# Technical Service Information

## FORD A4LD COOLER LINE FITTINGS

COOLER  
LINE  
FITTINGS

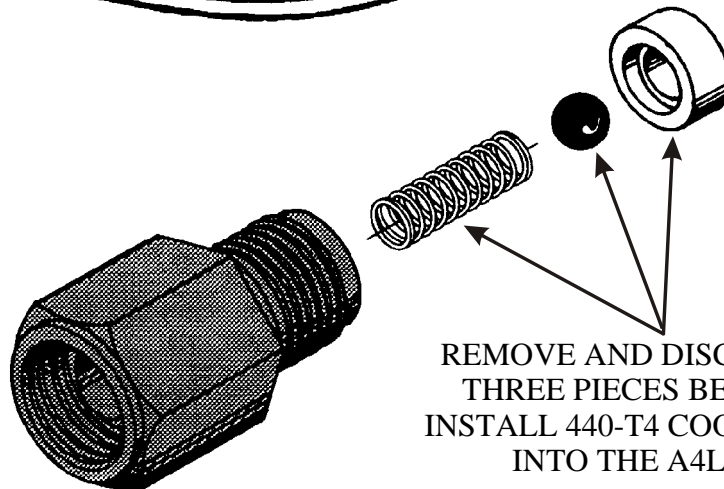
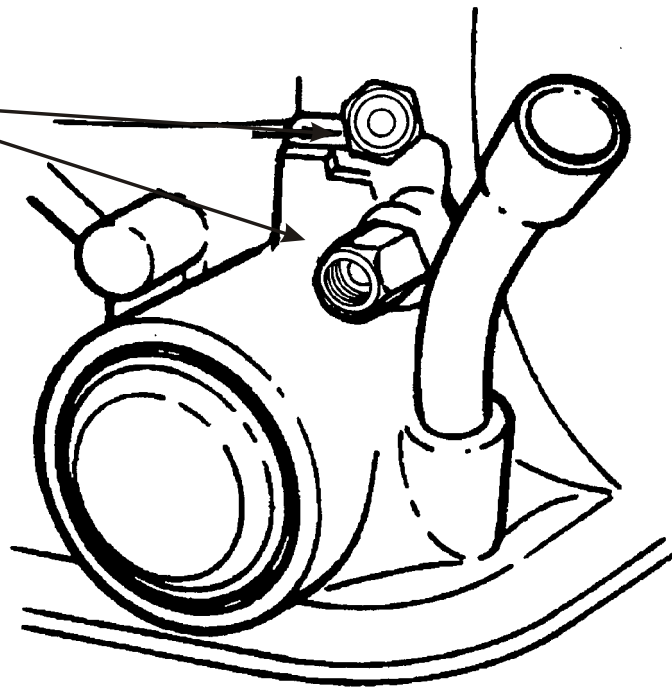
There are currently two different size cooler line fittings for the A4LD case. The cases for the small fittings (1/2" Pipe Thread) are no longer serviced by Ford Motor Co. There are adapters available from Ford, for installing the small cooler line fittings into a large thread case, and are available under OEM part number E7TZ-7D273 -B.

However, the large black cooler line fitting from the THM 440-T4 transaxle will also fit in the A4LD large thread case, but you must remove and discard the ball and spring from the 440 fitting. (See Figure 1).

REMOVE AND DISCARD THESE  
THREE PIECES BEFORE YOU  
INSTALL 440-T4 COOLER FITTING  
INTO THE A4LD CASE
